INDESIT company

Model type:
AMXXL120FR

Commercial code:
F037725

1200410 Exploded views

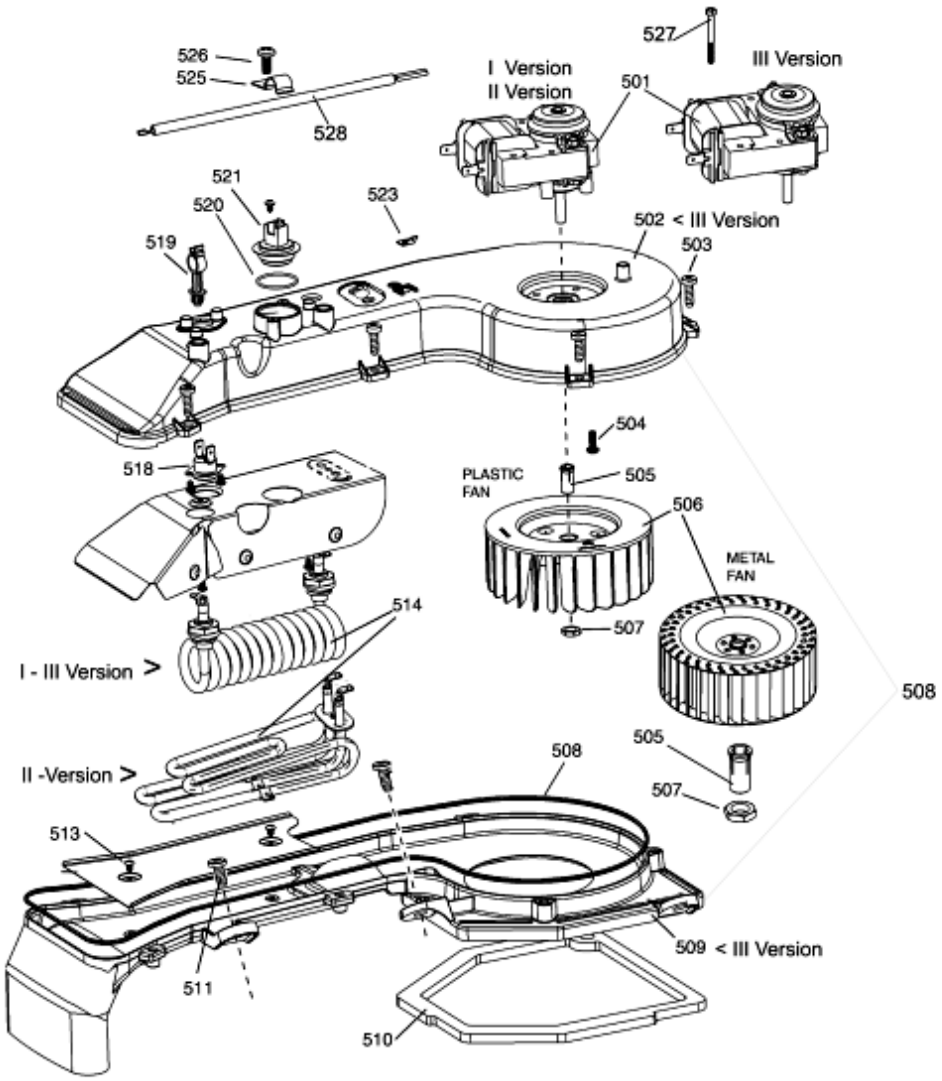
n4209c01: Heater Box Upper

The heater box top as listed in Servicenet and Partfinder is of the later type with the motor fixing that has the 4 bolts located through the top of the motor and fitted in production from serial number 70608.0001.

This heater box top can be used as a replacement for the original version of heater box manufactured before the GDA date code 40 but will require the following items.

The heater box top as fitted between GDA date code 40 and serial number 60612.0001 cannot be converted.

Item	Part	Description
501		Fan Motor
504		Screws
505		Fan Collet
506		Fan (Metal)
507		Nut
518		Thermofuse
525		Bracket
526		Screw

n4008c01: Smart Card - LVB/DRYERS

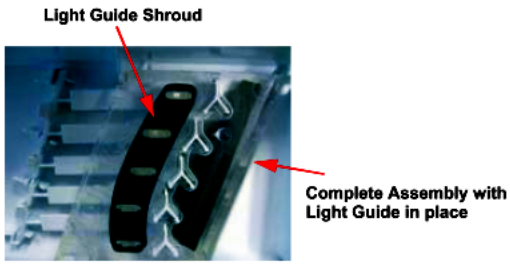
Beginning April 2008 spare parts warehouse started to manage the EVOII modules with eeprom fixed, these can only be programmed with smart card/palmare/pc.

Attention!! The premodification with eeprom socket can be programmed with smart card/palmare/pc using a blank eeprom or with pre programmed eeprom.

Spare parts of modules with eeprom fixed/eeprom socket:

C00265676 with eeprom fixed - C00143068 with eeprom socket - for models with conducibility sensor
C00254298 with eeprom fixed - C00143068 with eeprom socket - for models without conducibility sensor
C00254297 with eeprom fixed - C00259941 with eeprom socket
C00254531 with eeprom fixed - C00143058 with eeprom socket
C00254297 with eeprom fixed - C00143057 with eeprom socket - for models without blocking drum
C00265697 with eeprom fixed - C00143057 with eeprom socket - for models with blocking drum
C00254297 with eeprom fixed - C00143056 with eeprom socket
C00254530 with eeprom fixed - C00259738 with eeprom socket
C00254533 with eeprom fixed - C00143060 with eeprom socket
C00254535 with eeprom fixed - C00145013 with eeprom socket
C00254530 with eeprom fixed - C00145551 with eeprom socket
C00254529 with eeprom fixed - C00142293 with eeprom socket
C00257406 with eeprom fixed - C00143989 with eeprom socket

n0508c01: Door Gasket Clamp Band

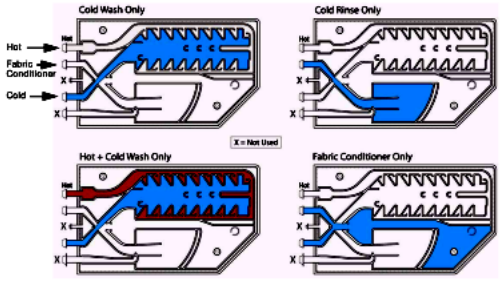
A New Polypropylene Gasket clamp band has been introduced in production from Serial number 80325.0000
The purpose is to provide added support to the inner rim of the door gasket.
